INSTRUCTION TO CONTRACTOR

Project:	Seamans Center For the Engineering Arts And Sciences South Annex Addition	ITC No. :	ITC-144
Project No.:	0452001	Date:	12/27/2016
ITC Title:	ITC-144 Concrete opening trim	Status:

N8 PLAN DETAIL

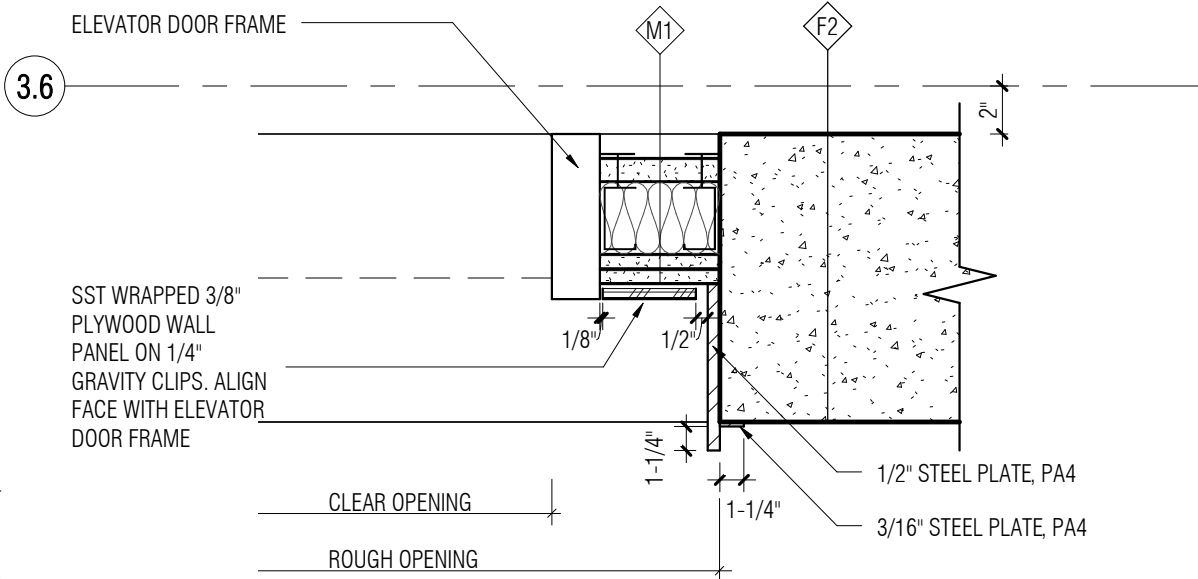
1. Revise detail N8/A502 per attached drawing ITC-129.1. Due to unacceptable concrete openings, painted steel trim is being added at all door openings at Stair 5 and Stair 6. Provide paintable sealant at joint between steel plate trim and hollow metal door frame. Head detail at openings is similar to jamb detail.

All door openings at Stair 5
 and Stair 6 shall receive
 painted steel trim as shown.

3. Steel plate trim shall be welded on unexposed surfaces. Joint between horizontal steel members to be hairline. Fasten steel trim to concrete walls with concrete screws recessed below surface of plate. Fill recess with Bondo type filler to achieve smooth and even surface.

L15 PLAN DETAIL

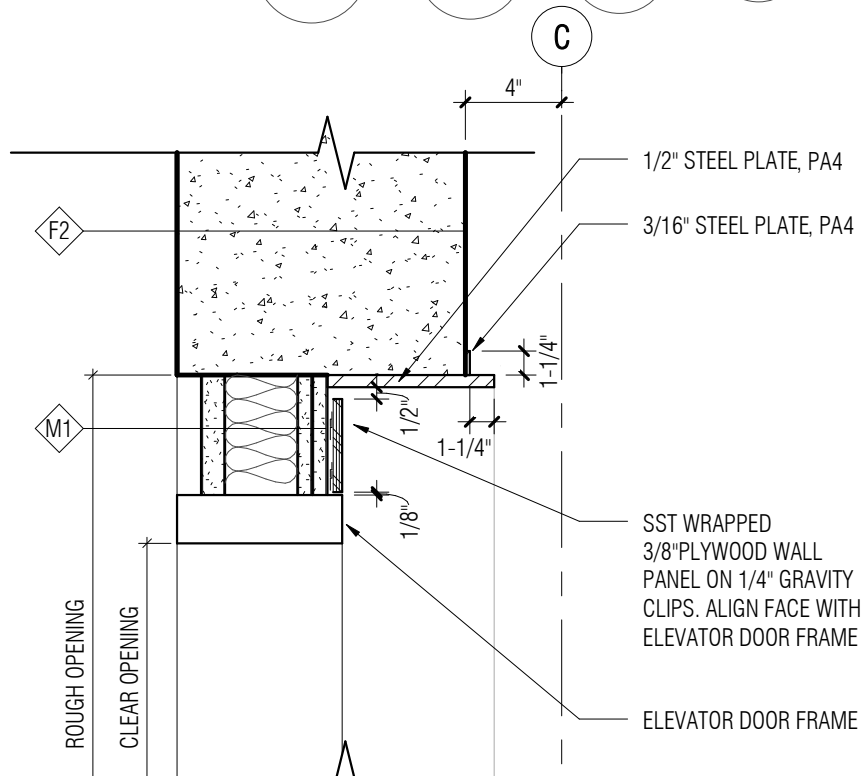
2. Revise detail L15/A650 per attached drawing ITC-129.2. Due to unacceptable concrete openings the construction around the elevator door openings is being revised. Omit metal framing, plywood, painted gypsum board and painted steel plate to the room side of wall type M1 and replace it with painted steel trim and stainless steel wall panels. Stainless steel wall panel finish to match elevator door and frame and grain direction to be vertical.
